SUBJECT: **Appeal of Subdivision Tentative Plan / Urban Growth Area Preliminary Declaration / Class 3 Site Plan Review / Class 2 Adjustment / Tree Regulation Variance / Class 1 Design Review Case No. SUB-UGA-SPR-ADJ-TRV-DR23-02 – 2100 Block of Doaks Ferry Rd NW; Open Rebuttal**

On July 24, 2023, the City Council held a public appeal hearing for SUB-UGA-SPR-ADJ-TRV-DR23-02. The hearing was closed, and the record was left open until July 31, 2023, at 5:00 p.m. for anyone to provide additional written testimony. Any party was able to submit rebuttal to testimony given in the open record period until August 7, 2023, at 5:00 p.m. The applicant has until August 14, 2023, at 5:00 p.m. to submit final written rebuttal.

Attachment M – Polk County Survey CS13334 Segments

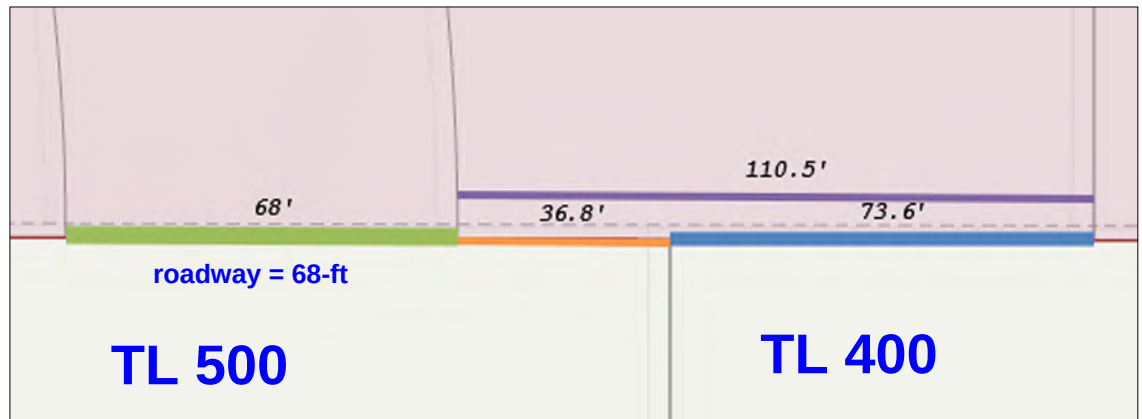
Please reconcile the distance between the DLC #66 NW corner and Tax Lot 400 NW corner before approving Titan Hill subdivision and development project.
